# \_37/3 prelim 7305 Willow Avenue Takoma Park Historic District

# HISTORIC PRESERVATION COMMISSION STAFF REPORT

Address: 7305 Willow Avenue	Meeting Date: 2/23/94
Resource:Takoma Park Historic District	Preliminary Consultation
Case Number: n/a	Tax Credit: No
Public Notice: 2/9/94	Report Date: 2/16/94
Applicant: Stacy Canan/Jonathan Zucker	Staff: Nancy Witherell
PROPOSAL: Addition of second story	RECOMMEND:Further study

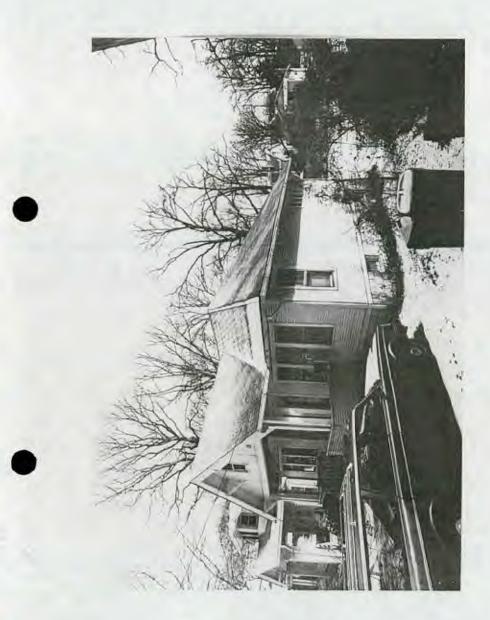
At the existing first floor, a fire place would be added to the exterior wall of the living room. Three small casement windows would be removed and a window matching the existing living room window would be added at the other side of the fireplace.

The central area of the rear addition would be two stories with a gable roof. The ridge of the addition would be lower than the proposed new roof ridge over the existing house. The additions flanking the central addition would be one story with shed roofs. The addition would be set in approximately 2 feet from the existing house at both sides. At the existing house in the rear there would also be shed dormers at the second floor similar, but smaller than the proposed dormers at the front elevation. The proposed second story addition would follow the guidelines for second story additions or expansions as stated in the guidelines for contributing residential resources: "second story additions or expansions should be generally consistent with the predominant architectural style and period of the resources (although structures that have been historically single story can be expanded) and should be appropriate to the surrounding streetscape in terms of scale and massing."
